TECHNICAL DRAINAGE STUDY UPDATE No.4

Skye Canyon
(Phase 2 Infrastructure)
City of Las Vegas, Nevada

Subject: Technical Drainage Study Update No.4 for Skye Canyon Ph.2 Infrastructure

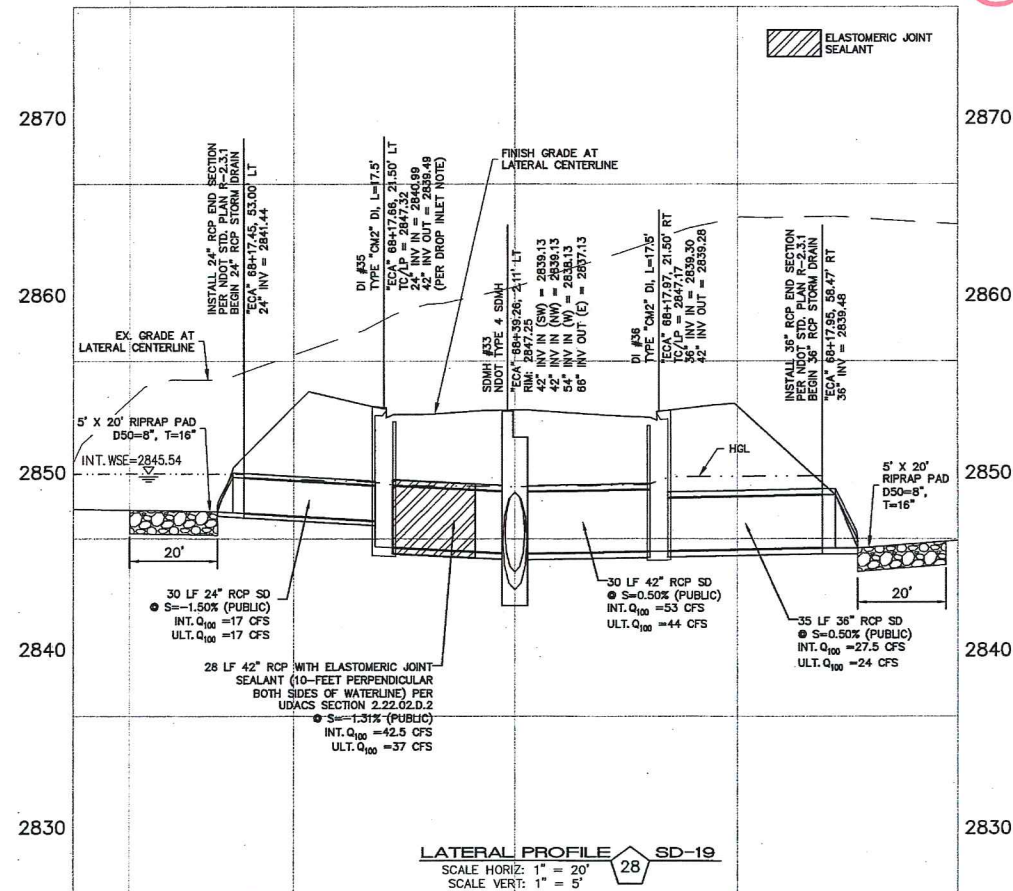
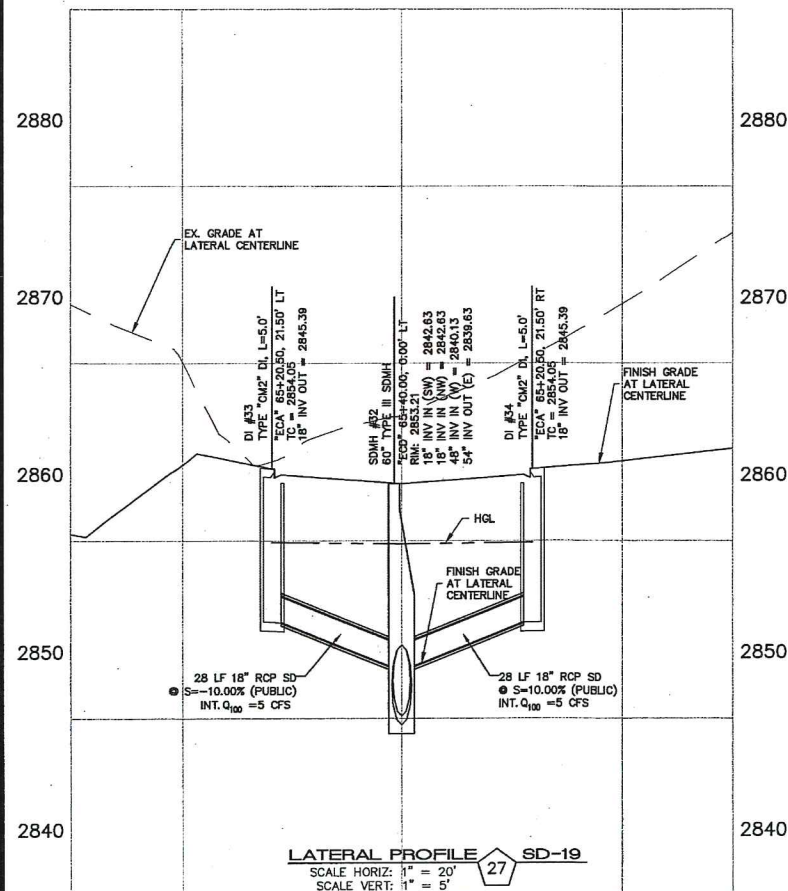
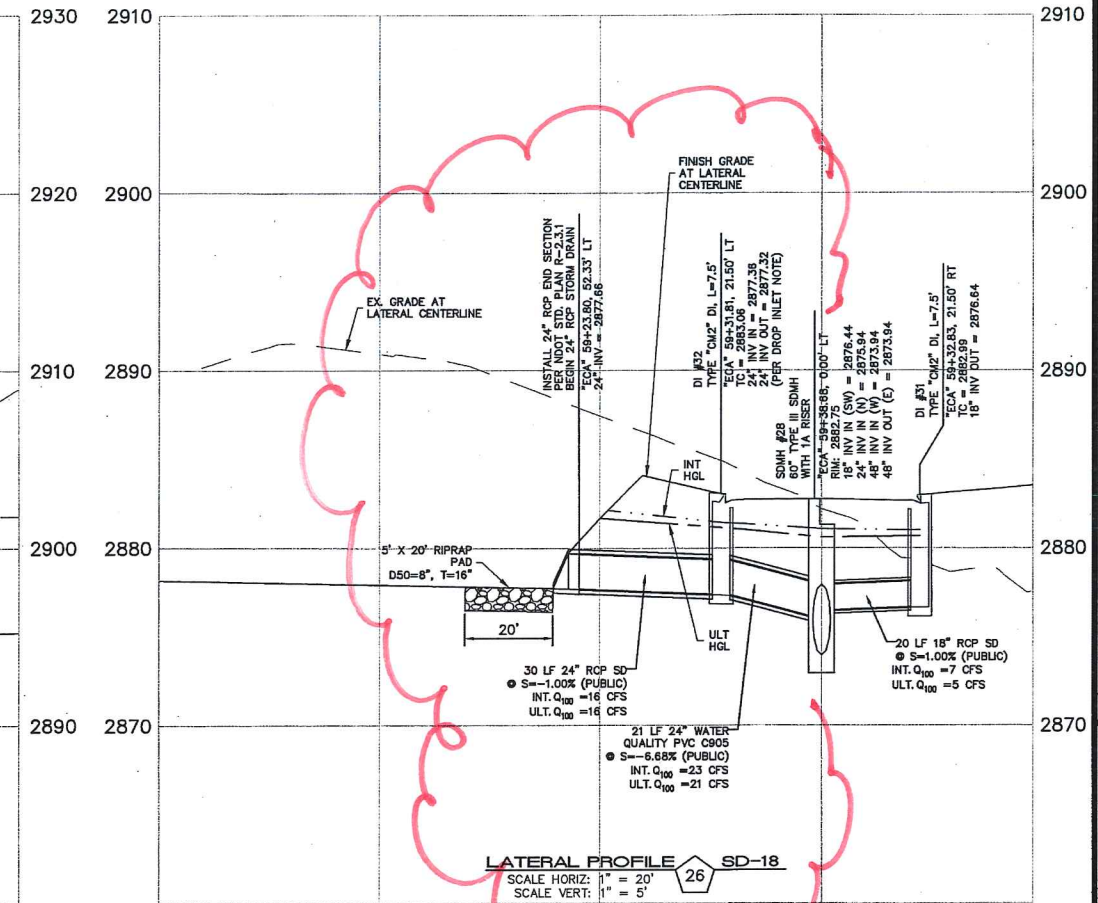
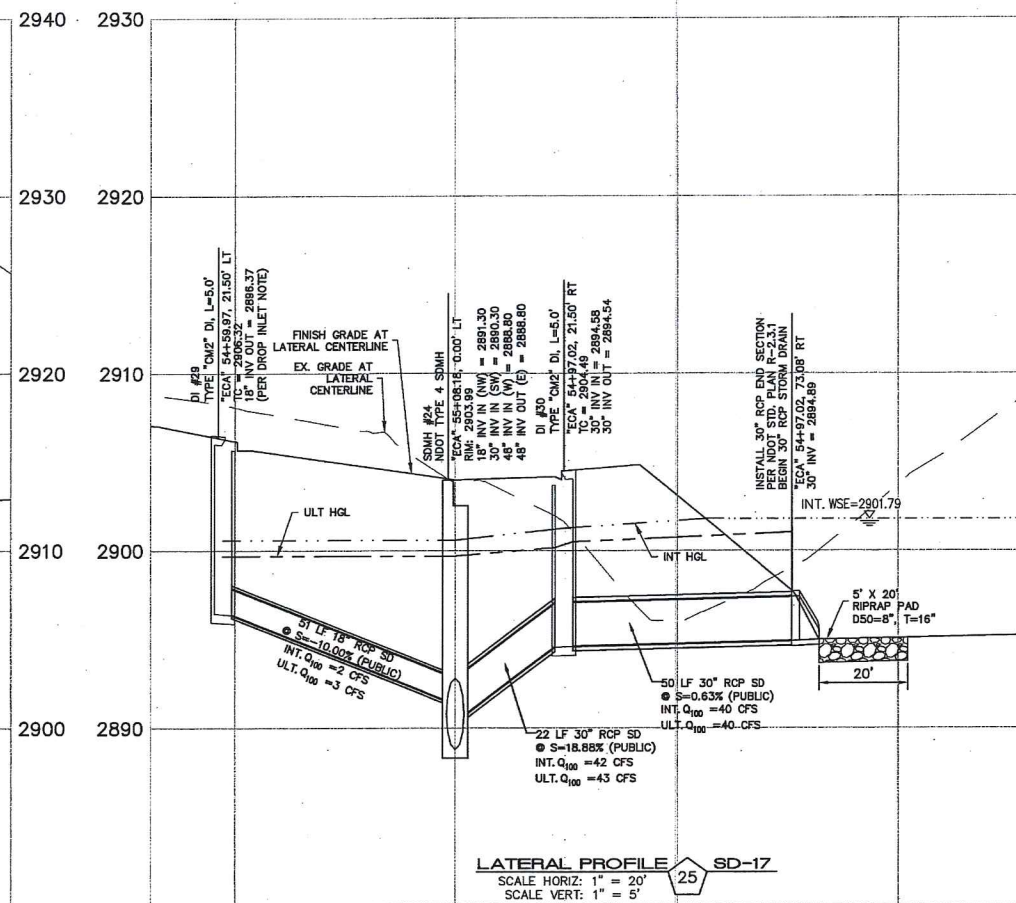
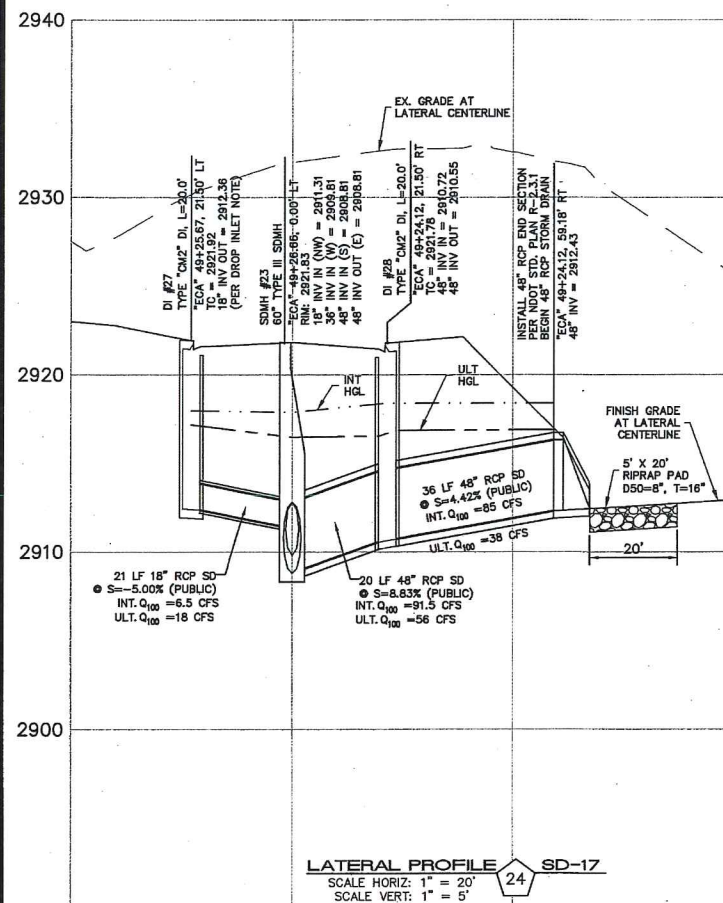
Natural struts and
inlet are being
relocated

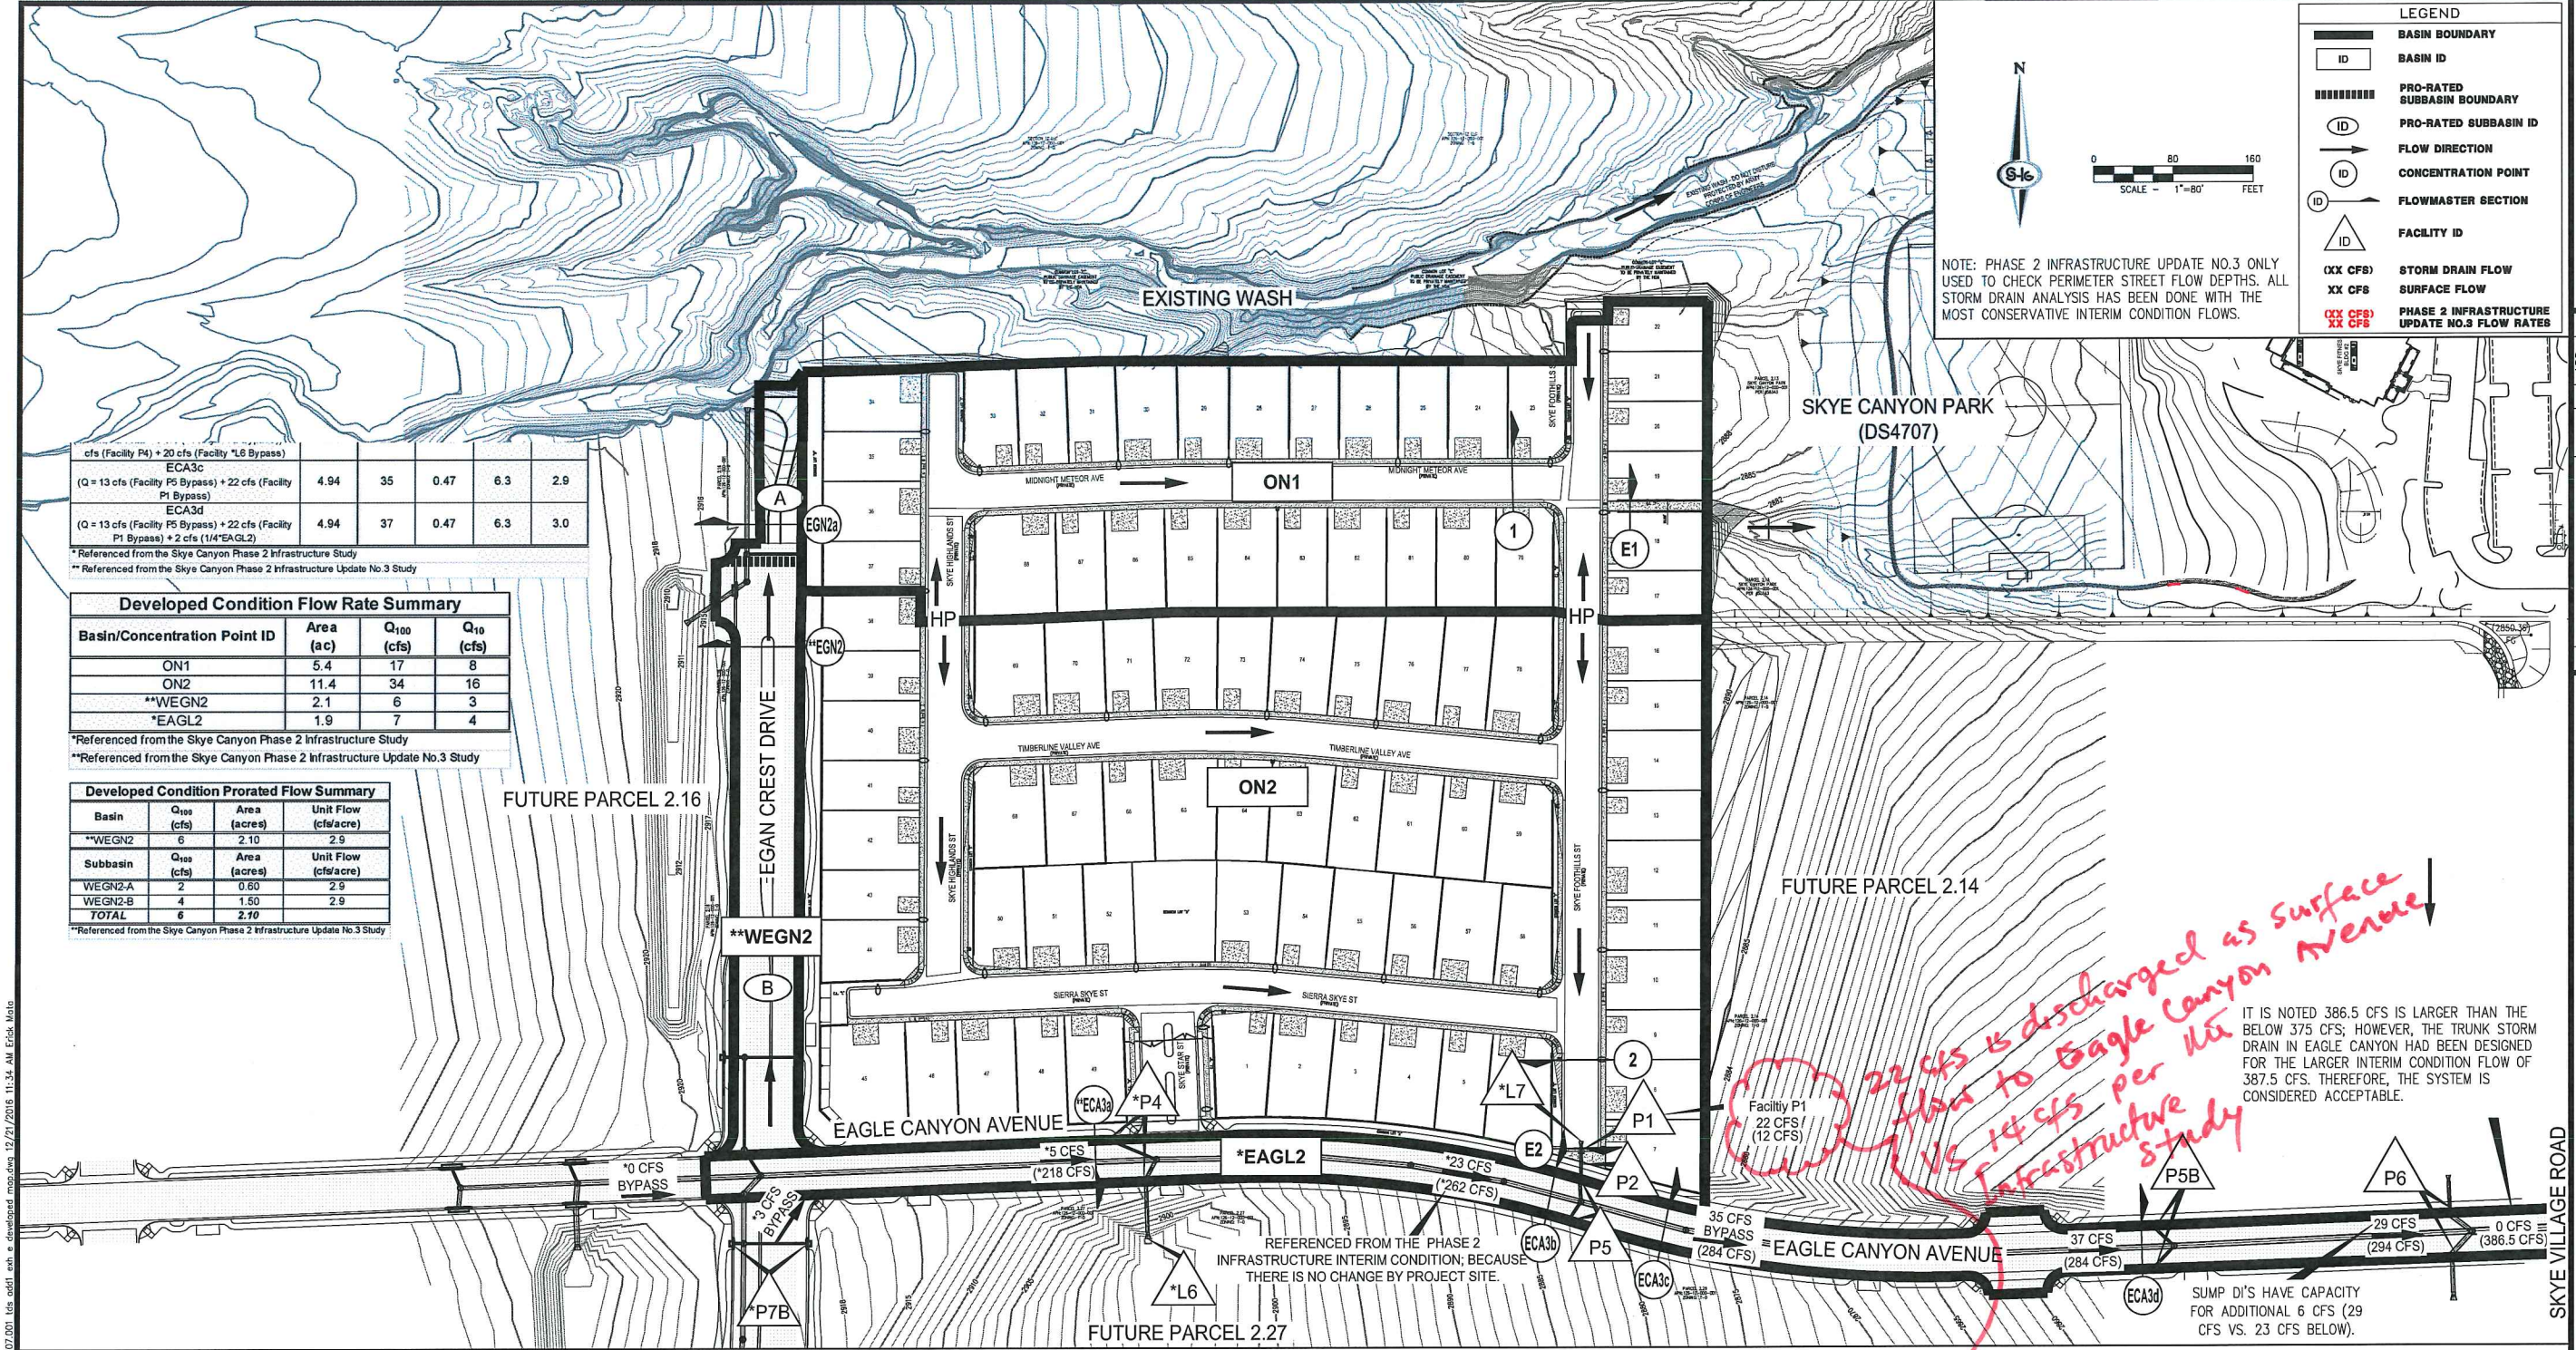
22 cfs is discharged as surface flow to Eagle Canyon Avenue
vs 14 cfs per the Infrastructure Study

IT IS NOTED 386.5 CFS IS LARGER THAN THE BELOW 375 CFS; HOWEVER, THE TRUNK STORM DRAIN IN EAGLE CANYON HAD BEEN DESIGNED FOR THE LARGER INTERIM CONDITION FLOW OF 387.5 CFS. THEREFORE, THE SYSTEM IS CONSIDERED ACCEPTABLE.

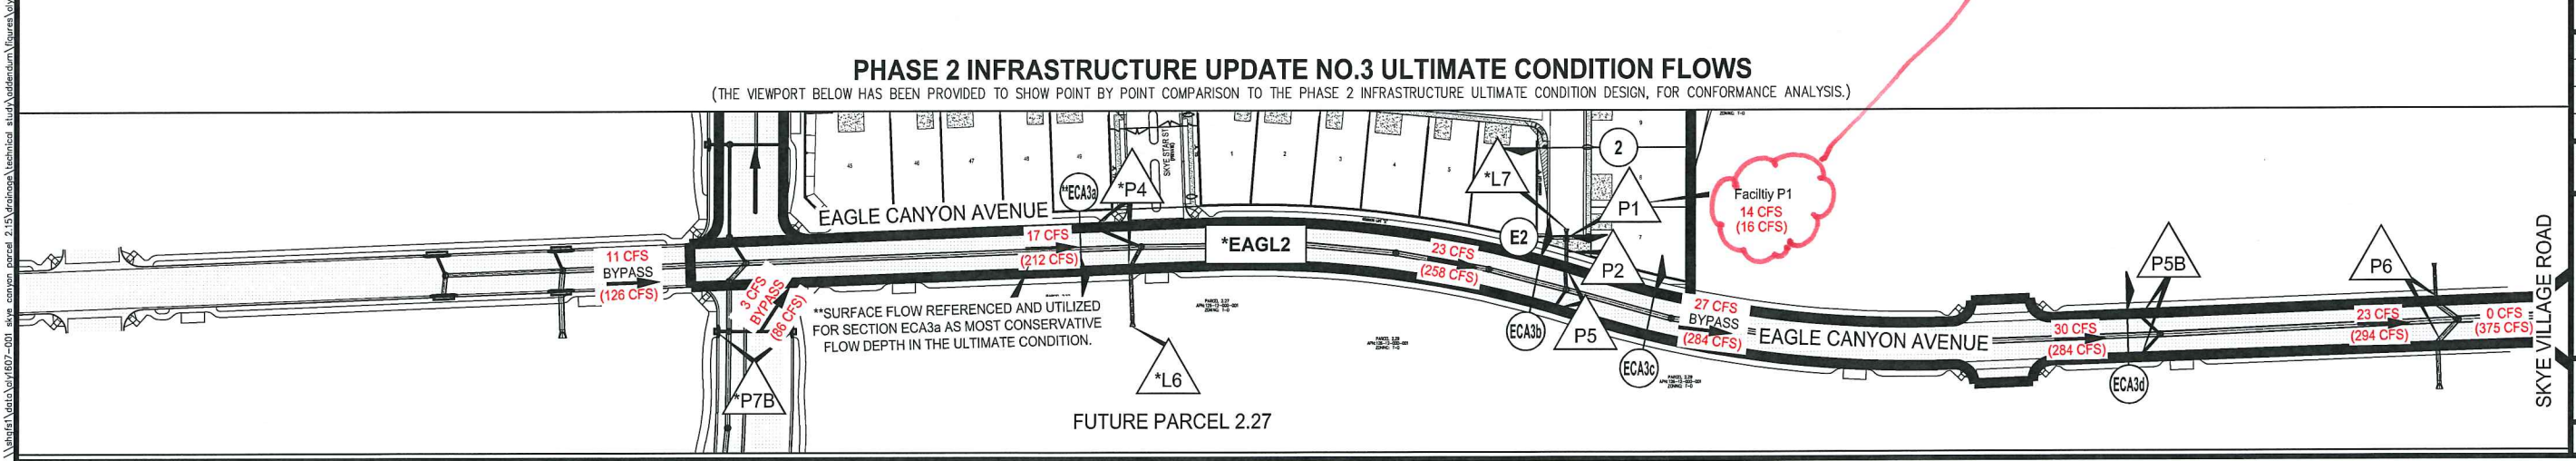
SUMP D'S HAVE CAPACITY FOR ADDITIONAL 6 CFS (29 CFS VS. 23 CFS BELOW).
